Enclosure 1
Changes to PSAR Chapters 2 and 3
(Non-Proprietary)

Figure 2.5-23: Profile A-A' (Boring Data Summary)

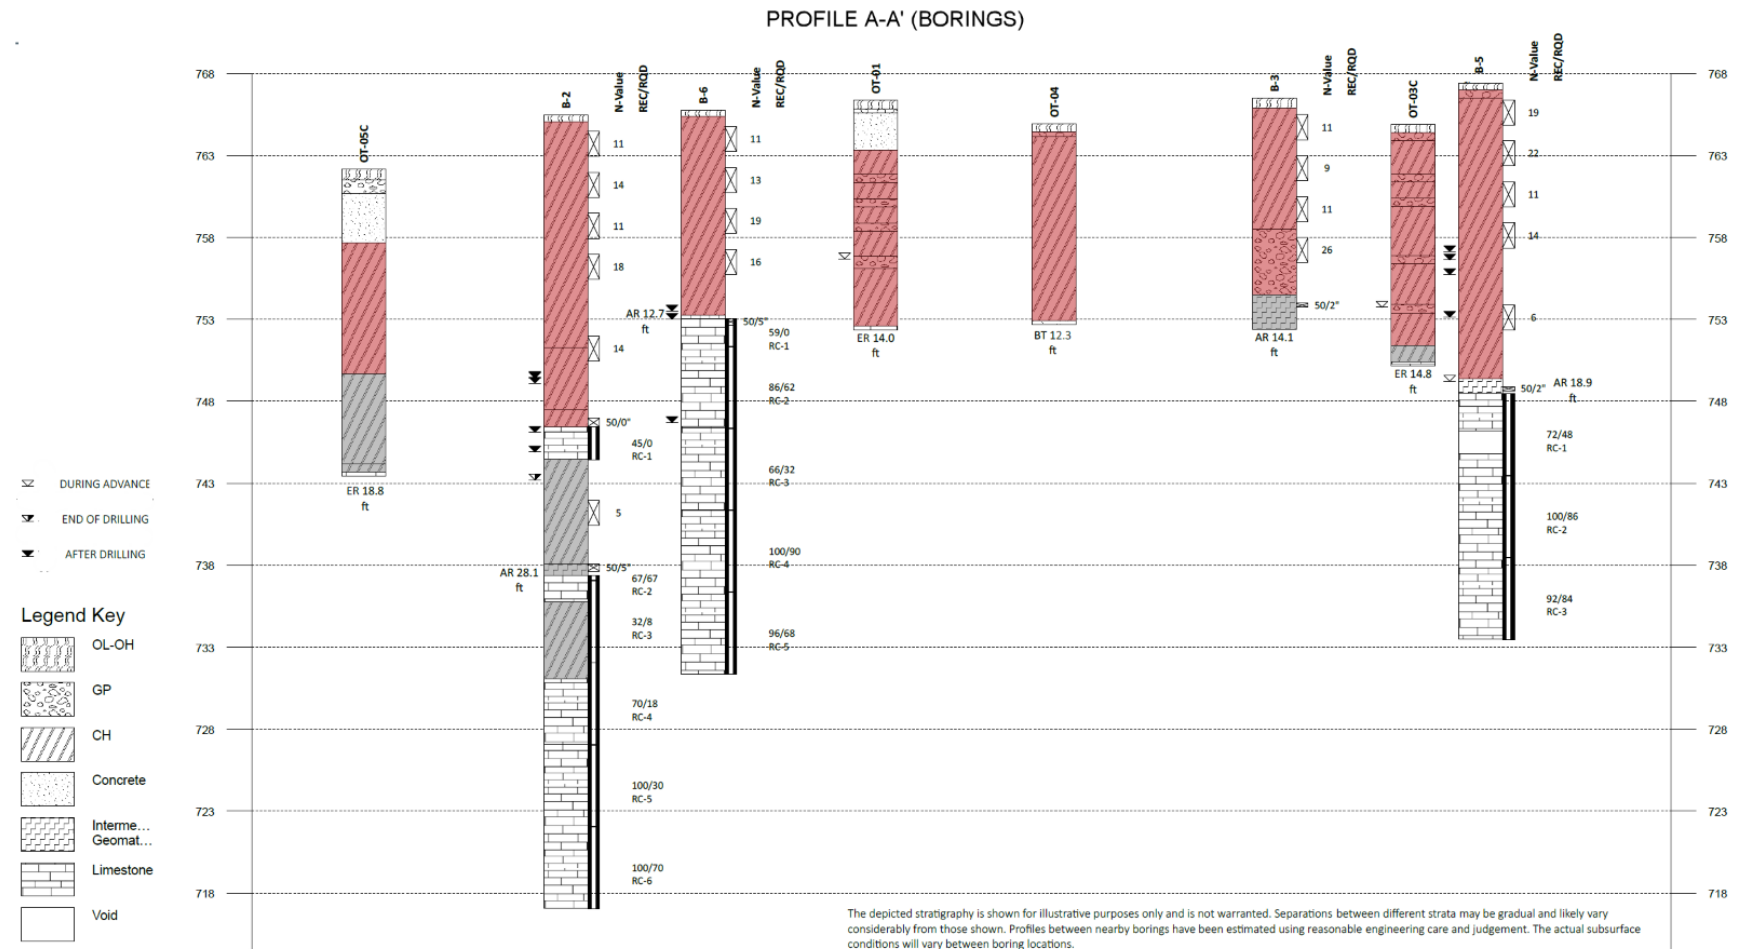
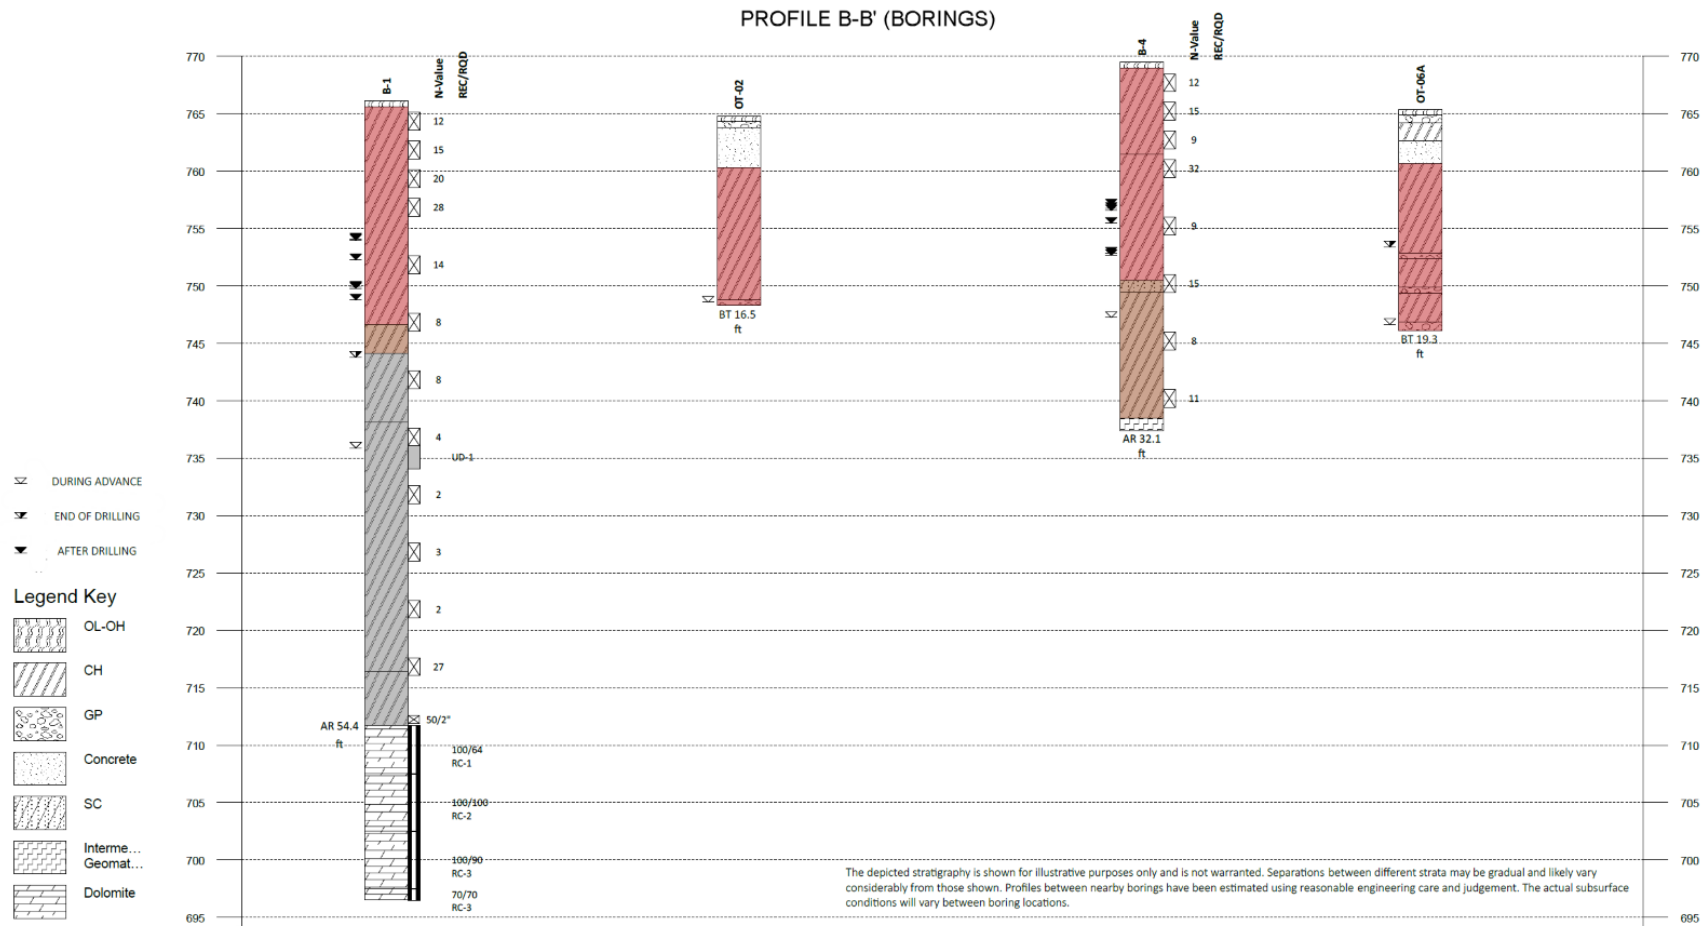
Figure 2.5-23 and Figure 2.5-24 provide profile sections of the soil borings and observation trenches with collected boring data summary. Section 2.5.2.3.2 describes the stratigraphic column based on the boring findings.
